# HISTORIC AND DESIGN REVIEW COMMISSION

**HDRC CASE NO:** 2024-020  
**ADDRESS:** 227 QUENTIN DR  
**LEGAL DESCRIPTION:** NCB 8411 BLK 6 LOT 63  
**ZONING:** R-6, H  
**CITY COUNCIL DIST.:** 7  
**DISTRICT:** Monticello Park Historic District  
**APPLICANT:** Reed Kirksey  
**OWNER:** Reed Kirksey  
**TYPE OF WORK:** Construction of a 1-story, 1,752-square-foot residential structure  
**APPLICATION RECEIVED:** February 09, 2024  
**60-DAY REVIEW:** April 7, 2024  
**CASE MANAGER:** Rachel Rettaliata

The applicant is requesting a Certificate of Appropriateness for the construction of a 1-story approximately 1,752-square-foot, single-family residential structure.

ROOF PLAN

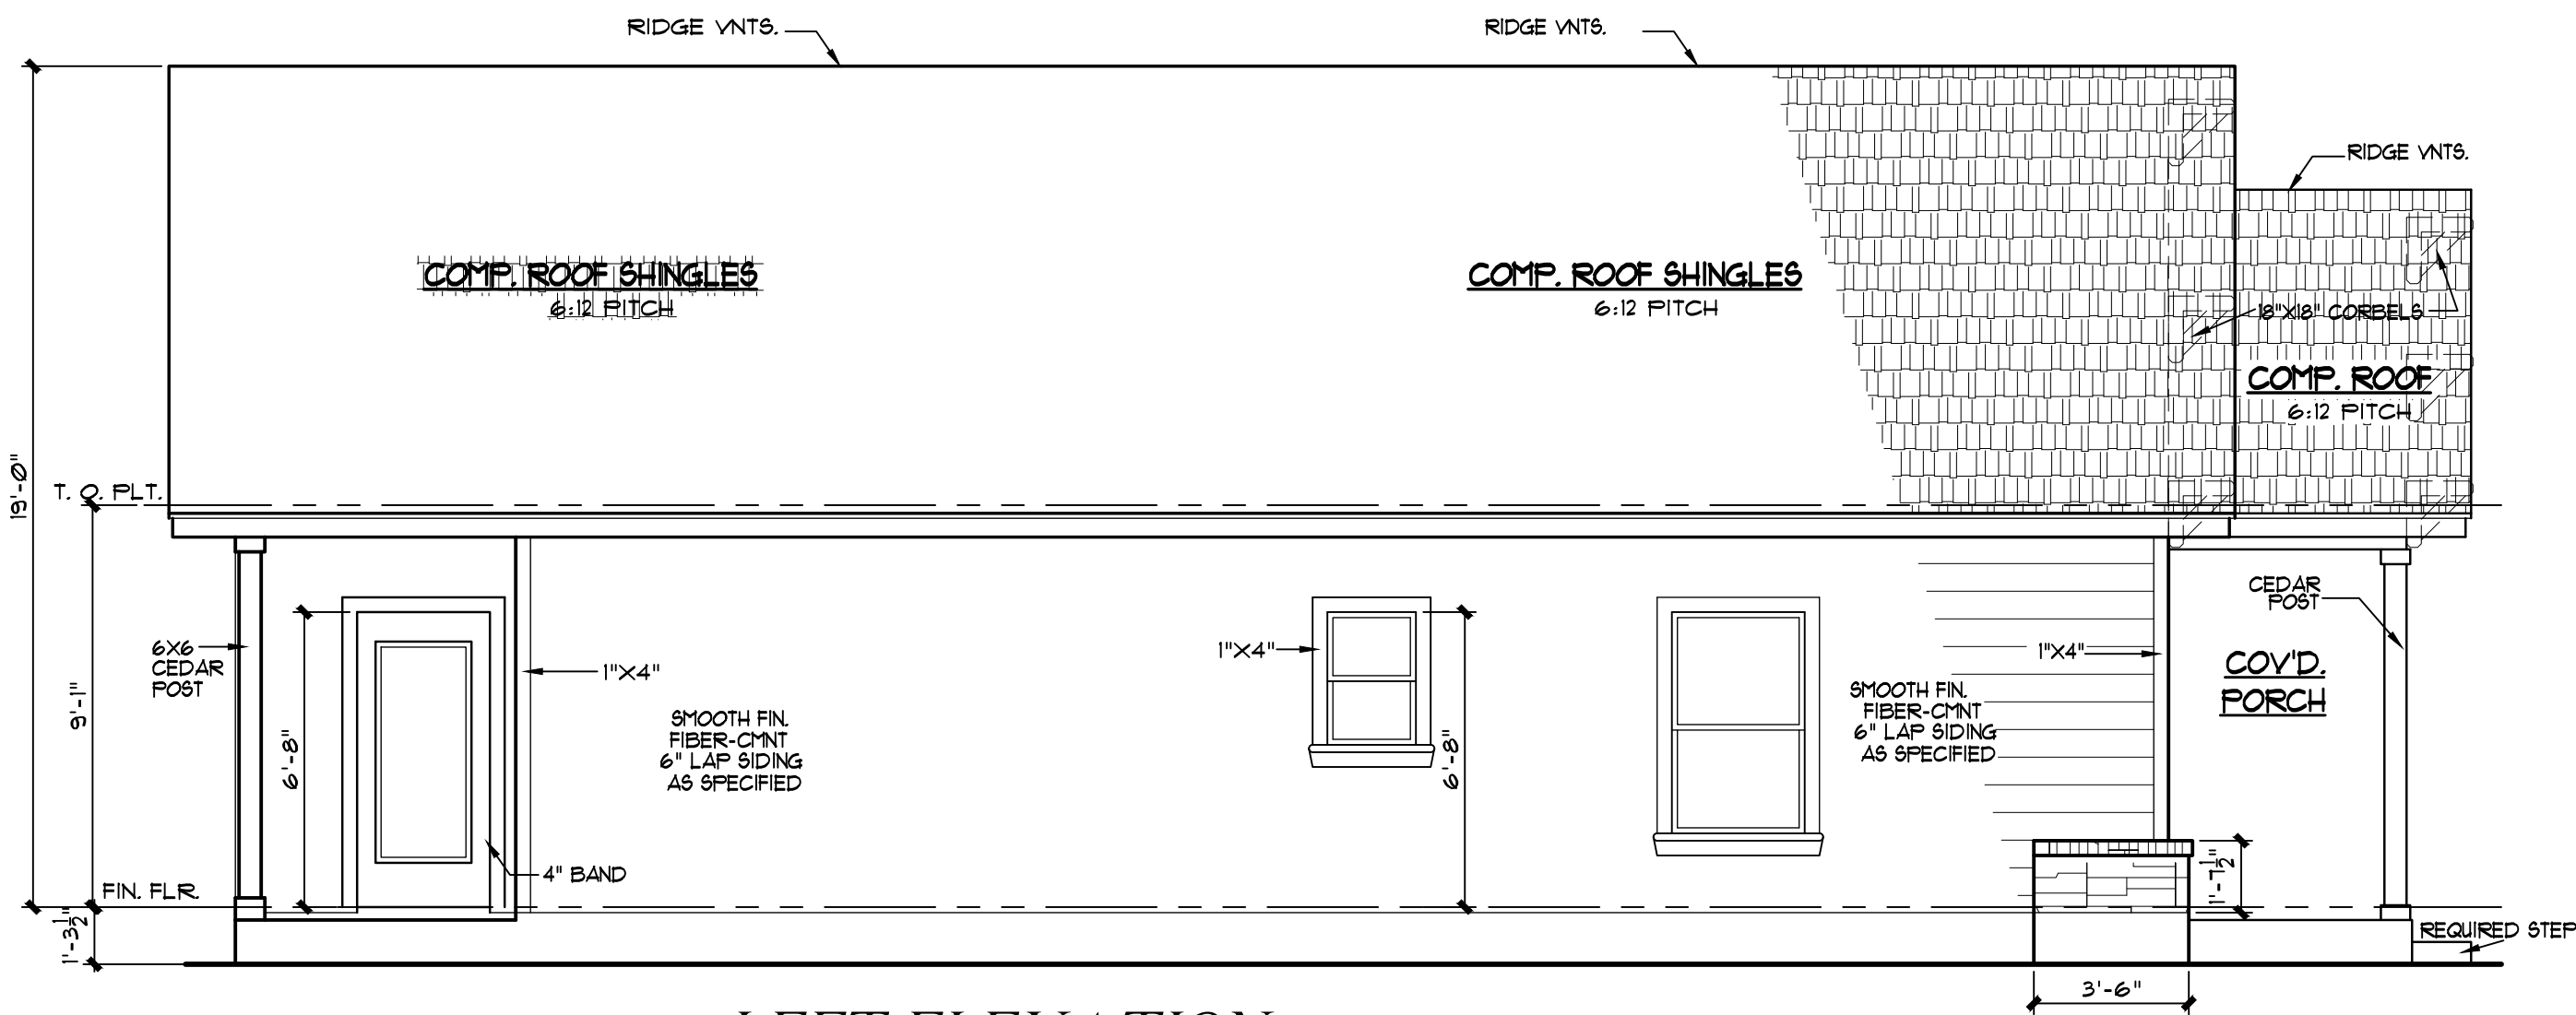
- iii. That the applicant modifies the roof pitch to be in keeping with the predominant lower-sloped roofs of adjacent structures based on finding f. Updated elevation drawings must be submitted to staff for review prior to returning to the HDRC. ***This stipulation has NOT been met.***

LEFT ELEVATION

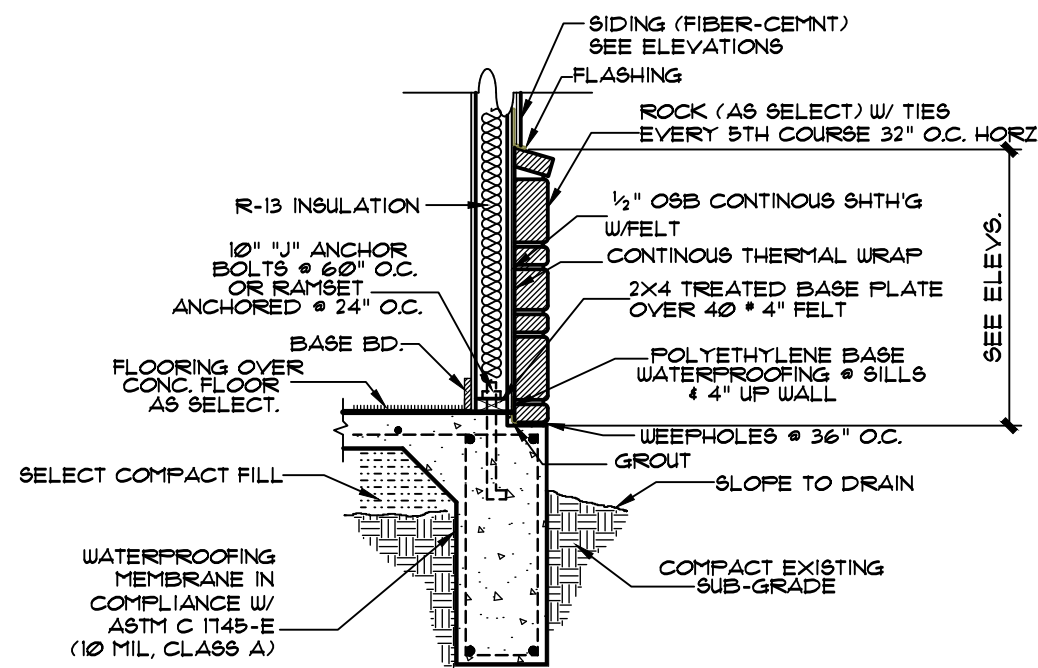
JF: On the left elevation, you have turned the corner with your stone wainscot but that is not the same for the right elevation. I would recommend that those skirts should match. If you are planning to fence the property, coming to the skirt with the fence would be a good stopping point for privacy fencing.
